Access Compliance Report

Public Rights-of-Way

(Curb Ramps)

Intersection ID: 14064	Main Street: E_PARK_AV	Cross Street: EUCLID_AV	Location: W
ADA ID: BF8DC9CD05DD	Ramp Type: PerpDiag	Initial Pass/Fail: Pass	Overall Compliance: No
Severity Score: 35.25			
Codes/Mitigation Info/Possible Solution		Field Measurements/Component Compliance

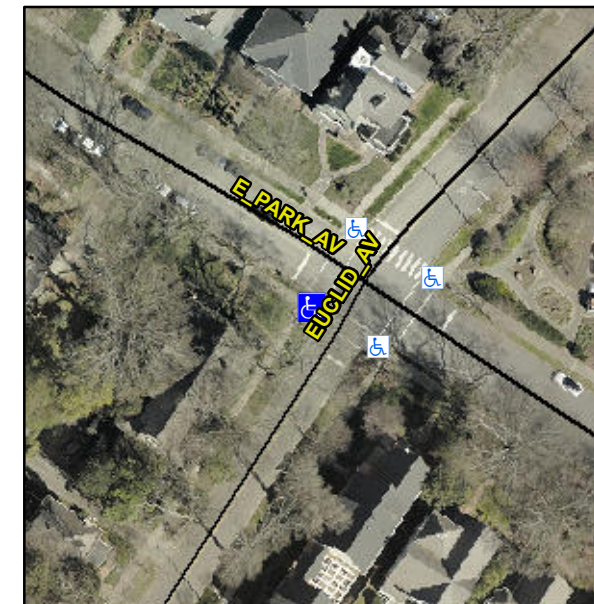
Not Found, R304.5.3, R304.2.1, R304.2.2-Perp, R304.3.2-Para, R305, R302.7, R302.7.2

Compliance	Description	Data	Compliance	Description	Data
N/A	Ramp Length (in)	82.0	Yes	Ramp Slope (%)	6.0
Yes	Ramp Width (in)	72.0	No	Ramp XSlope (%)	3.8
N/A	Flare Type LT	Sloped	N/A	Flare Type RT	N/A
N/A	Flare Slope LT (%)	5.1	Yes	Flare Slope RT (%)	2.6
N/A	Flare Traversable LT?	No	N/A	Flare Traversable RT?	Yes
No	Landing Length (in)	N/A	No	DWS Provided?	No
No	Landing Width (in)	N/A	N/A	DWS Contrast?	No
No	Landing Slope (%)	N/A	N/A	DWS Length (in)	N/A
No	Landing X Slope (%)	N/A	N/A	DWS Full Width?	No
N/A	Landing Curb? (Y/N)	No	N/A	DWS Offset (in)	N/A
N/A	Shared Landing?	N/A			
No	Gutter Ponding?	Yes	Yes	Gutter Slope (%)	4.5
No	Gutter Lip Ht (in)	1.0	Yes	Gutter X Slope (%)	0.8
N/A	Painted X Walk1?	Yes	N/A	Painted X Walk2?	Yes
	X Walk 1 Direction	To SE		X Walk 2 Direction	To NE
N/A	X Walk 1 Width (in)	113.0	N/A	X Walk 2 Width (in)	120.0
	X Walk 1 Slope (%)	5.0		X Walk 2 Slope (%)	6.3
	X Walk 1 X Slope (%)	0.7		X Walk 2 X Slope (%)	1.1

Yes	Ramp inside XWalk1?	Yes	Yes	Ramp inside XWalk2?	Yes
	Road Slope (%)	3.0	N/A	Clear Space?	Yes
	Road X Slope (%)	3.7	No	Clear Space to XWalk (in)	42.0
Yes	Any Obstructions?	No	Yes	Storm Grate/Utility Hazard?	No
	Obstruction Type			Storm Grate/Utility Type	
		N/A			N/A
			Yes	Surface Condition? (G/P)	Good

Remove & Replace Curb Ramp With Two New Directional Ramps or Equivalent. Restripe Crosswalk(s) To Provide Clear space.
